Our Ref: 21205

6 March 2023

**RE: 4 DELMAR PARADE AND 812 PITWATER ROAD, DEE WHY
TRAFFIC RESPONSE TO RFIS**

As requested, please find herein The Transport Planning Partnership (TPPP)'s response to Council's traffic engineering comments relating to the above proposed development.

TITLE
BASEMENT 2 - SWEPT PATH ASSESSMENT

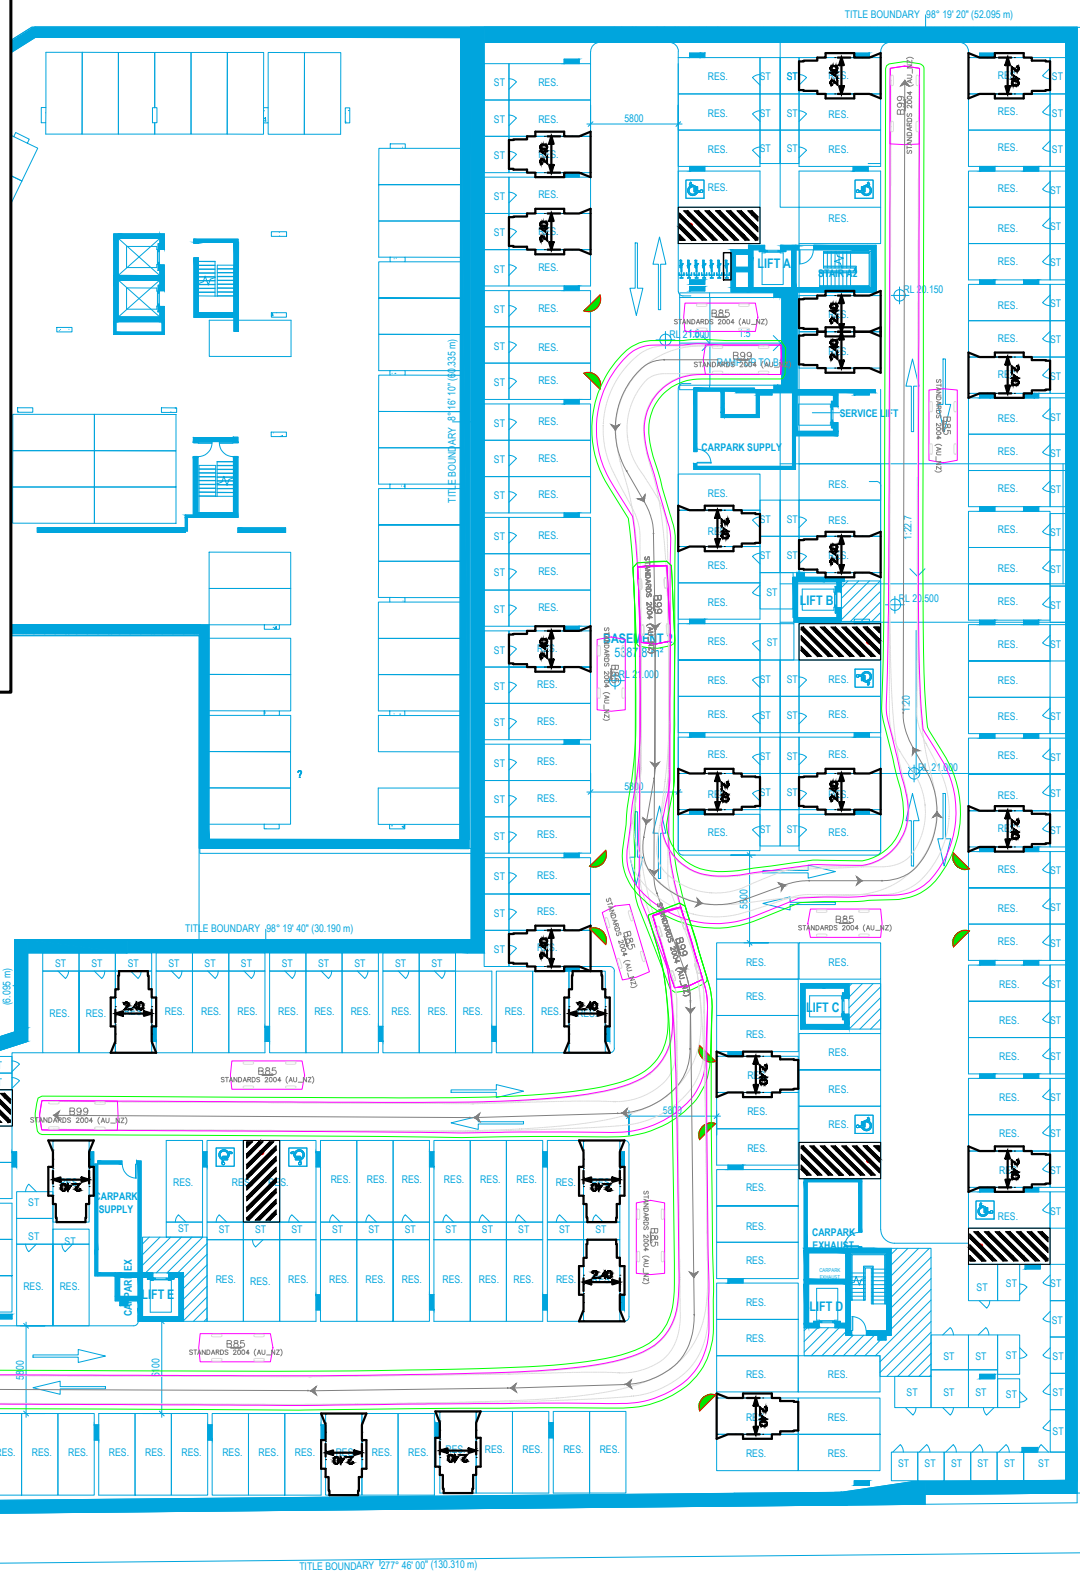
<p>Swept path plots provided in the traffic report reveal that there are a number of locations within both the basement 1 and basement 2 parking levels where the circulation area has not been designed to allow for passing of B85 & B99 vehicle as required by AS2890.1 clause 2.5.2(c). Given that there is a significant over supply of parking in terms of DCP requirements and given the number of vehicles likely to be circulating to and from parking spaces, deletion of some parking spaces and/or widening of circulation aisles to facilitate adequate passing opportunities is required.</p>	<p>If a car park is designed to accord with the Australian standard, it is often not possible for Autoturn to show that two cars can pass each other.</p> <p>However, two-way flows have been provided where sight lines are limited i.e. at the top and bottom of ramps. Within a standard circulation aisle, it is typical for two B99 cars not to pass each other at corners, however, there should be sufficient sight lines to enable drivers to negotiate access, as is the case with any typical car park.</p>
